Access Compliance Report Public Rights-of-Way (Curb Ramps)

Intersection ID: 15870 Main Street: CHEROKEE_RD **Cross Street: HUNTLEY_PL** Location: NW **Overall Compliance: No** ADA ID: 2E6B4F33DCAE Ramp Type: Perp Initial Pass/Fail: Fail **Severity Score:** 12.5

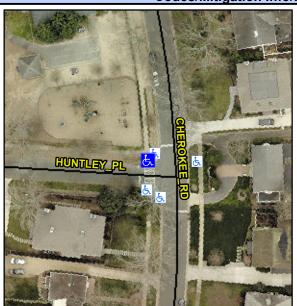
1 CCCIDIC CCIGNON	
Possible Solutions:	Comp
Remove & Replace Entire Ramp.	N/A
·	Yes
	N/A
	N/A
	N/A
	N/A
Surveyor Notes:	N/A
N/A	N/A
	N/A
	N/A
	N/A
PROW/ADA:	N/A
Not Found, R304.2.2	N/A
	N/A
	N/A
	N/A

Field Measurements/Component Compliance						
Compliance Description		Data	Comp	liance Description	Data	
N/A	Ramp Length (in)	77.0	No	Ramp Slope (%)	10.3	
Yes	Ramp Width (in)	48.0	Yes	Ramp XSlope (%)	1.2	
N/A	Flare Type LT	N/A	N/A	Flare Type RT	N/A	
N/A	Flare Slope LT (%)	N/A	N/A	Flare Slope RT (%)	N/A	
N/A	Flare Traversable LT?	N/A	N/A	Flare Traversable RT?	N/A	
N/A	Landing Length (in)	N/A	N/A	DWS Provided?	N/A	
N/A	Landing Width (in)	N/A	N/A	DWS Contrast?	N/A	
N/A	Landing Slope (%)	N/A	N/A	DWS Length (in)	N/A	
N/A	Landing X Slope (%)	N/A	N/A	DWS Full Width?	N/A	
N/A	Landing Curb? (Y/N)	N/A	N/A	DWS Offset (in)	N/A	
N/A	Shared Landing?	N/A				
N/A	Gutter Ponding?	N/A	N/A	Gutter Slope (%)	N/A	
N/A	Gutter Lip Ht (in)	N/A	N/A	Gutter X Slope (%)	N/A	
N/A	Painted X Walk1?	Yes	N/A	Painted X Walk2?	N/A	
	X Walk 1 Direction	To S		X Walk 2 Direction	N/A	
N/A	X Walk 1 Width (in)	127.0	N/A	X Walk 2 Width (in)	N/A	
	X Walk 1 Slope (%)	0.7		X Walk 2 Slope (%)	N/A
